Urban Design Assessment Report

Planning Proposals for Milton Street Precinct No. 149-163 and 165-171 Milton Street, Ashbury

Date: 14 September 2016

Figure 2- Section B-Section across from Milton St to the Oval near entry access road (Northern Site)

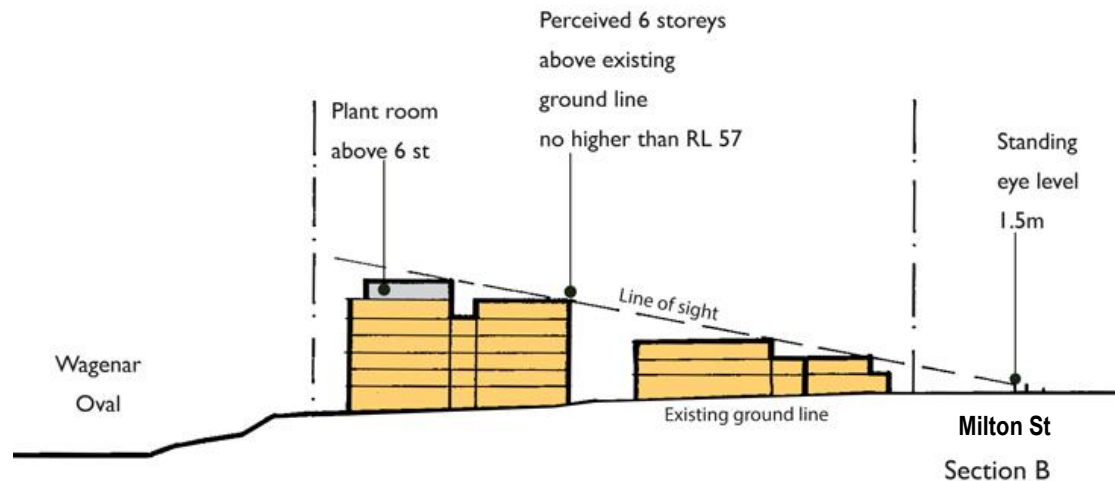
- A maximum height of no more than RL+57.0 with the exception of plant level (non-habitable) above recessed away from line of sight viewing from Milton and Trevenar Streets and a perceived height of 6 storeys. (Refer to Section B below)

Figure 22-'Built Form massing'

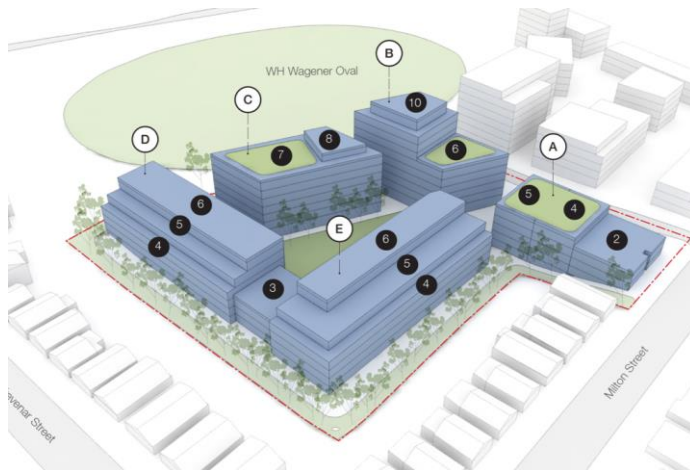
As per the Principles for Milton St discussed in Section 3.2 and discussions with Council, post the amalgamation, regarding the current schemes' scale and visible compatibility with the surrounding context, GMU prepared the following 'Recommended Concept Masterplan' to guide the applicants in arriving an appropriate built form for the two sites. The heights and access network recommended in this recommended concept masterplan have been amended based on sectional studies (Sections A-E) and newly received technical advice from Council's independent consultants. The sectional studies provide an analysis of the proposed building heights to understand at what heights the proposed developments protrude above the lines of sight, when viewed from Milton and Trevenar Streets. They also investigate the bulk and scale relationship between the appropriate built forms and the adjoining dwellings' backyards, to achieve a sensitive interface.

Figure 24- Milton St Frontage- no more than 2 storeys with single storey presentation

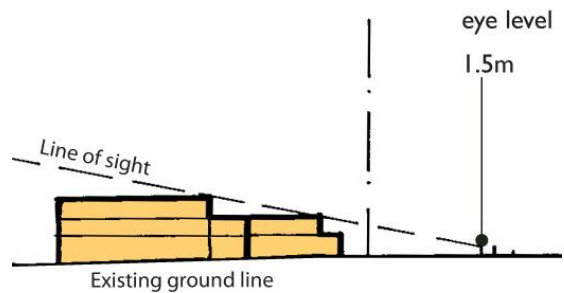
Milton St consists of predominantly single-storey dwellings. The proposed 2-3 storey and 2-5 storey built form proposed by both schemes is not supported, as it defers from the existing street scale and character of Milton St.

GMU considers a 2-storey building typology, with a single storey architectural feature (i.e. portico, porch or verandah) fronting Milton St, to be a more sympathetic built form.

Figure 25- Residential Interface adjacent to Yabsley Ave dwellings to be 3-storey building with a perceived height of 2 storeys and recessed top level away from line of sight

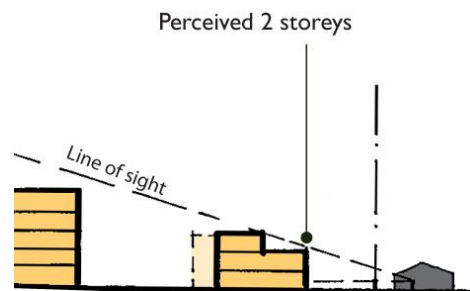
Section A is through the northern boundary of the northern site and the existing dwellings along Yabsley Avenue. It is recommended to have a built form of no more than 3 storeys and should only be perceived as 2 storeys from adjoining dwellings. The 3rd storey should be recessed away from line of sight.

Figure 26- Section from Milton St through the site to the Oval- Buildings to be kept under the line of sight from across Milton St

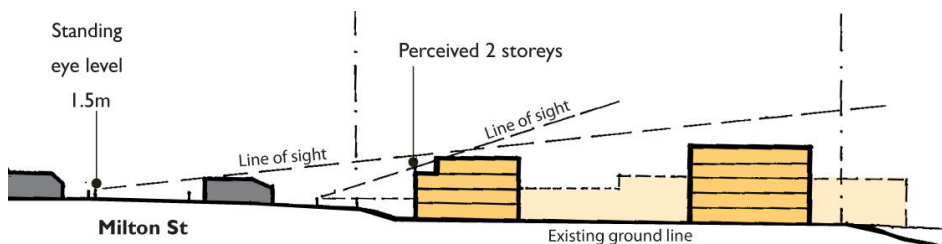
Section C is from east to west through Milton St and across the southern site. Due to the existing 4m level change from Milton St to the middle of the southern site, there is opportunity for an additional level from the existing ground line RL 36.5. The recommended built form for the eastern boundary of the southern site, at the rear of the dwellings along Milton St should be no more than 4 storeys with a perceived height of 2 storeys and the top level to be recessed away from line of sight.

Figure 27 - Residential interface at the SW corner of southern site (lowest point of the precinct)

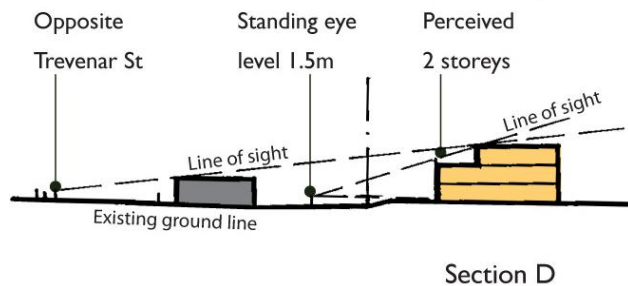
Section D is (south-west corner of the southern site and across Trevenar St) through the lowest point of the precinct. As the southern site sits slightly higher than the dwellings along Trevenar St, its built form will have more significant visual and privacy impacts onto the adjoining dwellings.

GMU recommends similar built form as Section A (perceived 2 storey building with the 3rd storey recessed away from sight) to respond to this edge condition.

Figure 28 - Residential Interface at the rear of Trevenar St dwellings

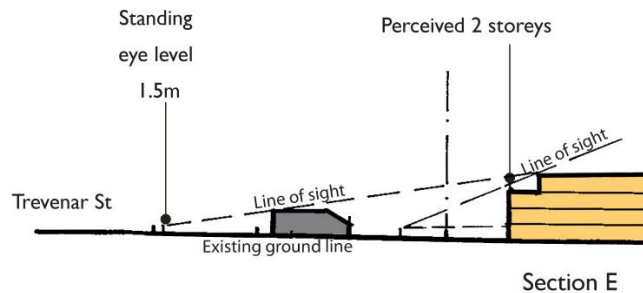
Section E is through Trevenar St and the south-eastern corner of the southern site.

For this eastern end of the southern boundary, a 4-storey built form with 2-2.5 storey perceived height is acceptable.

Figure 31: Access & Movement Diagram (Source: Urban Design Study by SJB Architects)

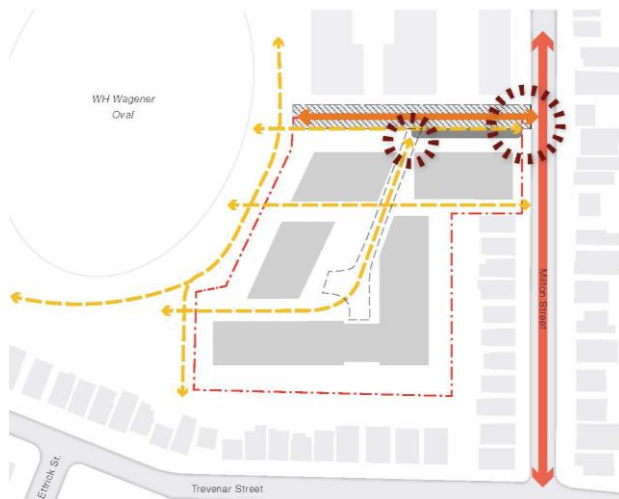
The current southern scheme has not proposed any internal road of the shared entry access road along the common boundary of the two sites. All future traffic will enter/exit the basement parking from this access road, however the number and location of basement car park entries off this access road are unclear. Due to the size of the site, the shared access road can only provide a limited number of basement car park entries. Waste collection for all the proposed buildings within the southern site will be difficult, especially with Council's limited distance of travel to waste collection points. The proposed single amalgamated car park will also result in future residents traversing long distances from their vehicles to their apartments. Similar to the northern site, GMU proposes a single-lane loop road with limited on-street parking that is connected to a number of basement parking entries encapsulated within proposed buildings.

2 pedestrian links are currently proposed (refer to Fig. 32), along the northern and southern facades of Buildings A & B, that directly connect Milton St to WH Wagener Oval. The location of these links is well considered as it directs the local community to the centre of the oval and could potentially open up district views to the east across the oval and Whitfield Avenue, providing a visual corridor from Milton St. The third pedestrian link connects the new access road to the Oval via the central communal open space. This linkage can be further extended into the northern site.

For both sites, the extent of all vehicular driveways should be minimised and parking entries should be encapsulated within buildings. Garbage collection should be carried out within the basement.

Figure 36- Section near the corner of Trevenar St and Milton St Figure 37- Western end of Trevenar St- at the precinct's lowest point

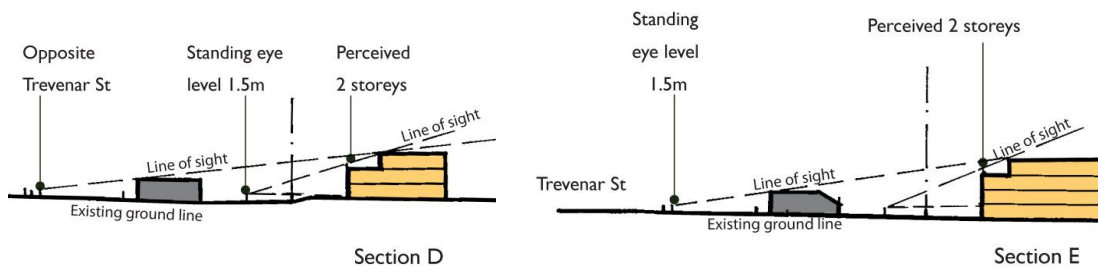
There is currently an insufficient level of detail to provide in-depth assessment on privacy. However, the taller forms along the rear gardens of the low scale dwellings along Yabsley Avenue, Milton and Trevenar Streets have their balconies facing directly to the adjoining properties, although they are setback at least 12m away from the common boundaries. Through sectional studies along the changing topography, GMU considers that these edge buildings especially Block 1 of the Northern Site, (Buildings D & E), are inappropriate to the residential interface and should be reduced to have perceived height of 2 storeys and no taller than 3-4 storeys high.
